Detailed Site Plan Departure from Design Standards New Carrollton Multifamily IV

DSP-22030
DDS-24001

STAFF REPORT

SUBJECT: Detailed Site Plan DSP-22030
 Departure from Design Standards DDS-24001
 Type 2 Tree Conservation Plan TCP2-009-2024-01
 New Carrollton Multifamily IV

Figure 4: Outdoor Recreational Facilities

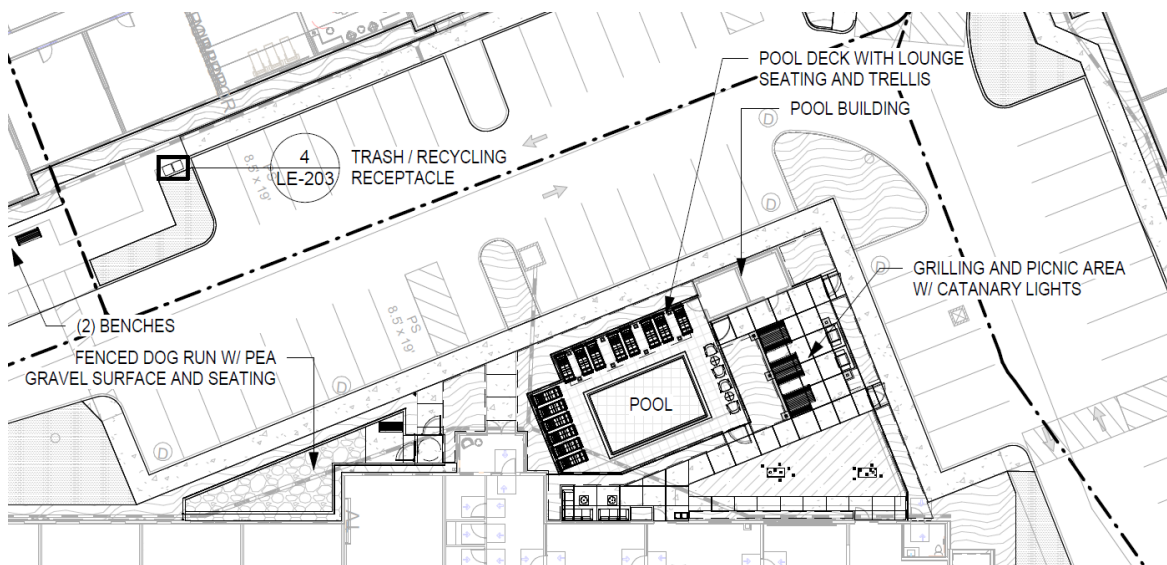
The submitted plan shows an outdoor recreational site located to the north of Building 1. However, a list of the proposed outdoor recreational facilities is not noted on the plan. A condition is included herein, requiring the applicant to itemize the quantity and value of outdoor recreational facilities and amenities, such as picnic tables with chairs, other types

of tables and chairs, grills, lounge chairs, and other amenities to be installed in the synthetic turf. The submitted plans show that the outdoor recreational site is being constrained by two bays of surface parking spaces immediately to its north and east. A condition is included herein, requiring the applicant to remove the parking spaces located to the north of Building 1 to enlarge the outdoor recreational site.

Figure 5: Indoor Recreational Facilities within Building 1

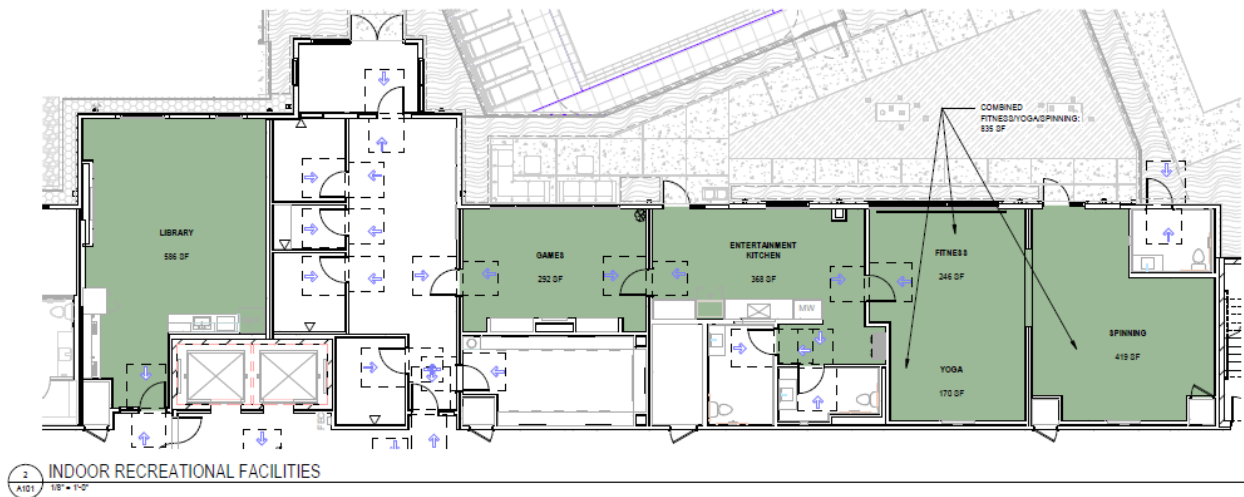
The submitted architectural floor plans also show that indoor recreational facilities are located within Buildings 1, 2, and 3. However, the facilities to be included in these rooms are not specified. A condition is included herein, requiring the applicant to provide large-scale, detailed floor plans showing the location of the proposed facilities within these rooms, and itemize the quantity and value of these amenities in the recreational facilities schedule on the coversheet. Another condition is included herein, requiring the applicant to add indoor recreational facilities to Building 4 and, if impossible, explain how future residents in Building 4 access indoor recreational facilities in other buildings. In addition to those indoor and outdoor recreational facilities, the applicant proposed a fenced dog run area, with a pet waste station. Given that a proposed library is proximate to the proposed dog run area, a condition is included herein, requiring the applicant to provide noise mitigation measurements to mitigate noise impacts on the library.
